RE: Interior Moisture Investigation – Follow-up review
Lincoln School Apartments
Hingham, Massachusetts
BET No. 25009

This correspondence has been prepared as requested to report our observations regarding the repairs completed to the exterior walls outside of Apartment 109 at the Lincoln School Apartments in Hingham, MA.

Heavy staining on rear elevation – photo taken January 23, 2025

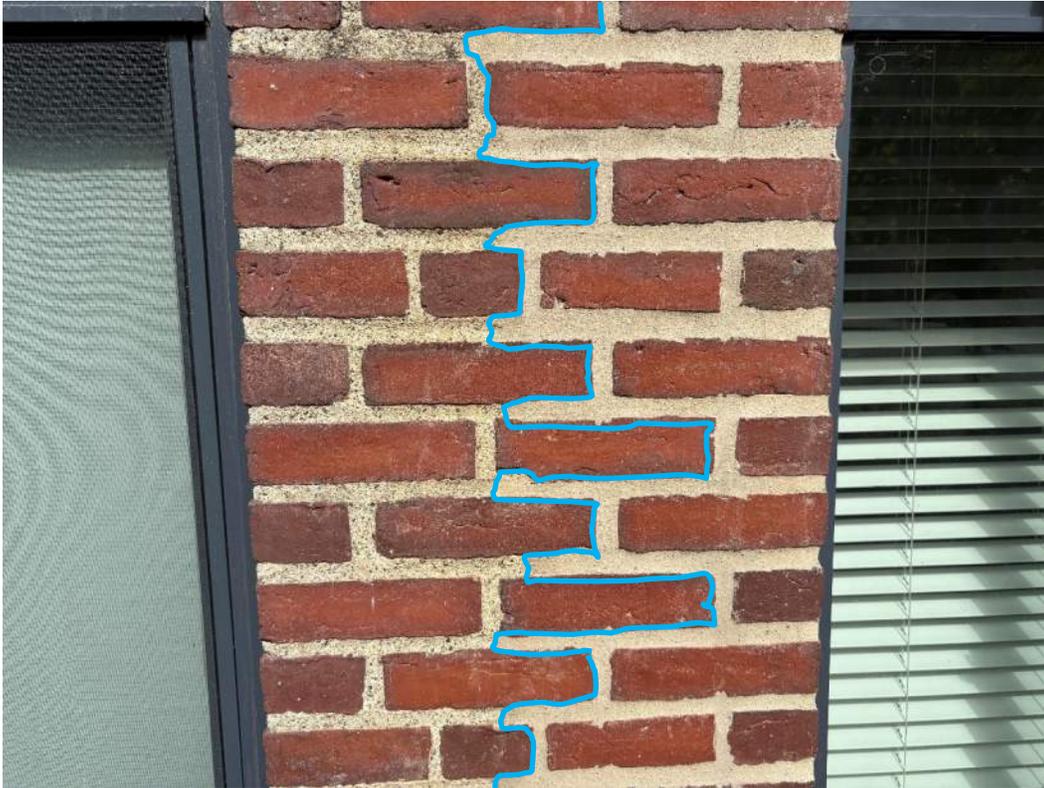
At first glance, the ground floor brick masonry exterior wall on the rear of the building is notably cleaner and nearly free of efflorescence staining and moss/algae. Only small faint areas of the white, chalky stains were observed above two of the three rear windows.

Wall area between windows with original mortar (left) meeting the new mortar (right)

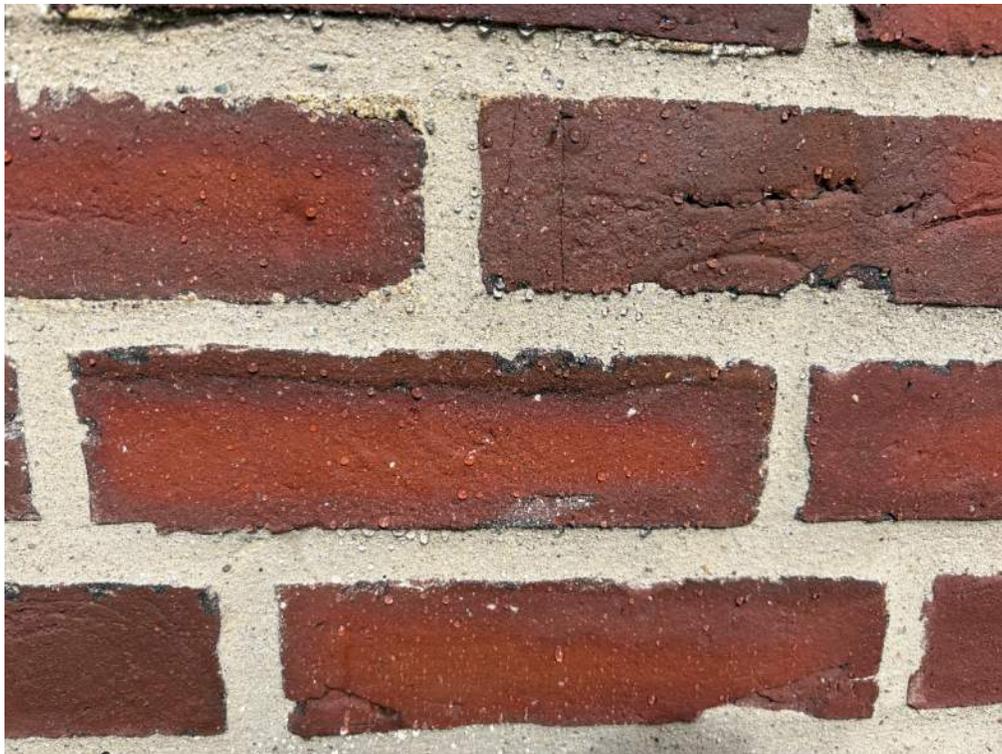
Upon examination, it was found that the brick masonry joints between the cast stones at the foundation level and the cast stone water table below the second floor windows have been repointed. Although it is unknown whether the workers removed the mortar to a minimum depth of 1", the new mortar appears solid and continuous with no cracking. A small hammer was used to test the strength and thickness of the new mortar in several random locations via hammer strikes. No cracks or chipping were produced, indicating the new mortar has been set to solid materials. If the substrate materials were soft/deteriorated, or if the new mortar was not pressed into the substrate, the hammer blows would typically crack the new mortar.

The newly applied mortar has less exposed aggregate than the original mortar, however it should be noted that the original mortar is heavily weathered. The color of the new mortar appears to closely replicate the original. It was also found that the new mortar was applied so that it is nearly flush with the exterior surface of the bricks.
